Access Compliance Report Public Rights-of-Way (Curb Ramps)

Intersection ID: 32294 Main Street: STEWARTS BEND LN Cross Street: SULLIVAN RIDGE DR Location: NE ADA ID: B80BAF1A7FB3 Ramp Type: PerpDiag Initial Pass/Fail: Fail **Overall Compliance: No Severity Score:** 22.5

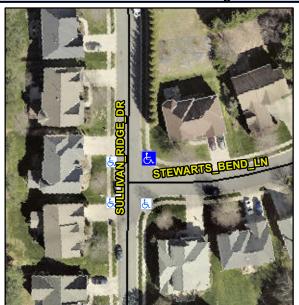
Possible Solutions: Remove & Replace Curb Ramp With Two New Directional Ramps or Equivalent. Surveyor Notes: N/A PROW/ADA: Not Found, R304.5.1, R304.2.2, R304.5.3

Field Measurements/Component Compliance					
Compliance Description		Data	Comp	liance Description	Data
N/A	Ramp Length (in)	49.0	No	Ramp Slope (%)	9.3
No	Ramp Width (in)	43.0	No	Ramp XSlope (%)	3.9
N/A	Flare Type LT	N/A	N/A	Flare Type RT	N/A
N/A	Flare Slope LT (%)	N/A	N/A	Flare Slope RT (%)	N/A
N/A	Flare Traversable LT?	N/A	N/A	Flare Traversable RT?	N/A
N/A	Landing Length (in)	N/A	N/A	DWS Provided?	N/A
N/A	Landing Width (in)	N/A	N/A	DWS Contrast?	N/A
N/A	Landing Slope (%)	N/A	N/A	DWS Length (in)	N/A
N/A	Landing X Slope (%)	N/A	N/A	DWS Full Width?	N/A
N/A	Landing Curb? (Y/N)	N/A	N/A	DWS Offset (in)	N/A
N/A	Shared Landing?	N/A			
N/A	Gutter Ponding?	N/A	N/A	Gutter Slope (%)	N/A
N/A	Gutter Lip Ht (in)	N/A	N/A	Gutter X Slope (%)	N/A
N/A	Painted X Walk1?	No	N/A	Painted X Walk2?	No
	X Walk 1 Direction	To W		X Walk 2 Direction	To S
N/A	X Walk 1 Width (in)	N/A	N/A	X Walk 2 Width (in)	N/A
	X Walk 1 Slope (%)	0.1		X Walk 2 Slope (%)	5.2

X Walk 1 X Slope (%)	4.2		X Walk 2 X Slope (%)	0.8
N/A	Ramp inside XWalk1?	N/A	N/A	Ramp inside XWalk2?	N/A
	Road Slope (%)	0.1	N/A	Clear Space?	N/A
	Road X Slope (%)	1.3	N/A	Clear Space to XWalk (in)	N/A
N/A	Any Obstructions?	N/A	N/A	Storm Grate/Utility Hazard?	N/A
	Obstruction Type			Storm Grate/Utility Type	
		N/A			N/A
			Yes	Surface Condition? (G/P)	Good
	The last of the la
